**PLANNED UNIT DEVELOPMENT &
PLANNING APPROVAL STAFF REPORT****Date: February 5, 2009****NAME**

Mobile Carnival Association

Planning Approval to allow a float barn in a B-4, General Business District, and Planned Unit Development Approval to allow two buildings on a single building site.

SITE PLAN

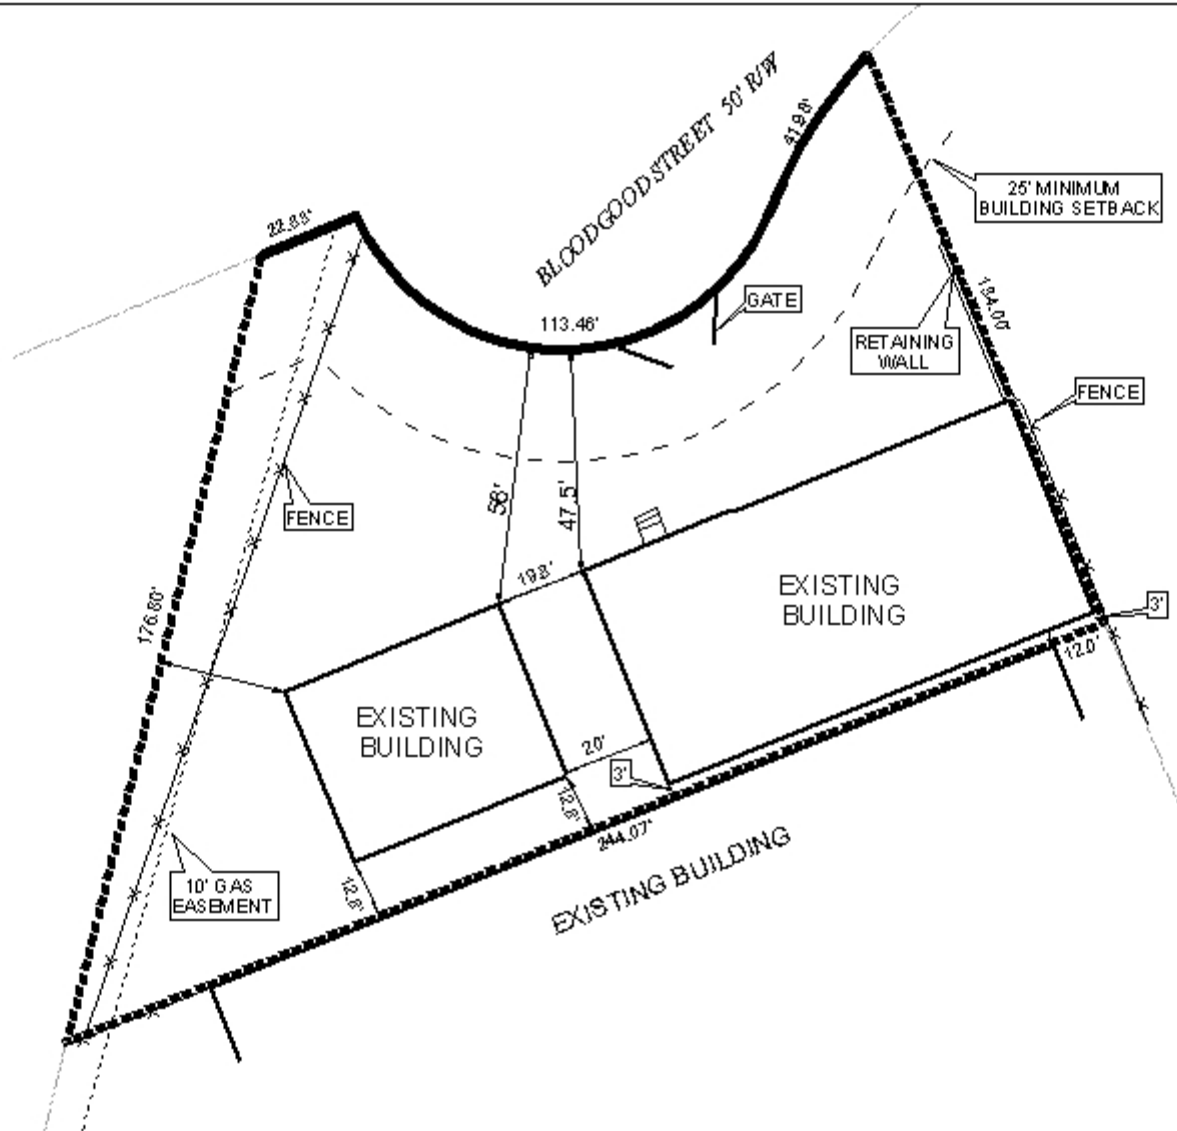
Show Minimum FFE on plat. No fill allowed without an approved Flood Study. Must comply with all storm water and flood control ordinances. Must provide detention for any impervious area added since 1984 in excess of 4,000 square feet. Any work performed in the right of way will require a right of way permit.

Driveway number, size, location, and design to be approved by Traffic Engineering and conform to AASHTO standards.

The applicant proposes to utilize two existing structures for float barns: no improvements appear to be proposed for the site. The larger structure is 5,000 square feet in size, and the smaller structure is 2,000 square feet. Aerial photographs from 2006 depict the site as unpaved.

The Zoning Ordinance does not specifically define parking requirements for a float barn, but a reasonable interpretation utilizing office/warehouse parking requirements could be assumed. The required parking ratio would be 1 space per 300 square feet of office area, and 1 space per three warehouse employees. No information was provided, however, regarding the amount of office space versus warehouse space, and no information was provided regarding the number of warehouse employees. It is understood by staff that day to day use of the site may not occur, due to the seasonal nature of Mardi Gras, however, it would seem reasonable to expect some accommodation for vehicular parking as well as some level of improvement of the site to meet the tree and landscape requirements of the Zoning Ordinance. The applicant should either revise the site plan to depict compliance with the requirements of the Zoning Ordinance, or should apply for parking surfacing, maneuvering variances as well as a variance regarding compliance with the tree and landscape requirements.

If the site will be illuminated at night, lighting shall comply with the requirements of Section 64-4.A.2. of the Zoning Ordinance, which states that “*lighting facilities used to illuminate signs, parking areas, or for other purposes shall be so arranged that the source of light does not shine directly into adjacent residence properties or into traffic.*”

- 1) Compliance with Engineering comments (*Show Minimum FFE on plat. No fill allowed without an approved Flood Study. Must comply with all storm water and flood control ordinances. Must provide detention for any impervious area added since 1984 in excess of 4,000 square feet. Any work performed in the right of way will require a right of way permit.*)

- 2) Revision of the site plan to indicate the amount of office space in each structure in square feet, and the number of warehouse employees;
- 3) Revision of the site plan to depict paved maneuvering and parking, with parking adequate to serve the existing office space within the buildings, and at minimum one additional space for the warehouse area (more if required by the number of warehouse employees);

- 4) Revision of the site plan to depict compliance with the tree and landscaping requirements of the Zoning Ordinance;
- 5) Placement of a note on the site plan stating that any changes to the site plan will require new applications for Planning Approval and Planned Unit Development approval prior to the issuance of any permits;

- 6) Placement of a note on the site plan stating that the site will be illuminated in accordance with the requirements of Section 64-4.A.2. of the Zoning Ordinance; and

- 7) Placement of a note on the site plan stating that the site is limited to the existing curb-cut onto Bloodgood Street, with any change in the size, design or location of the curb-cut to be approved by Traffic Engineering and be in compliance with AASHTO standards.
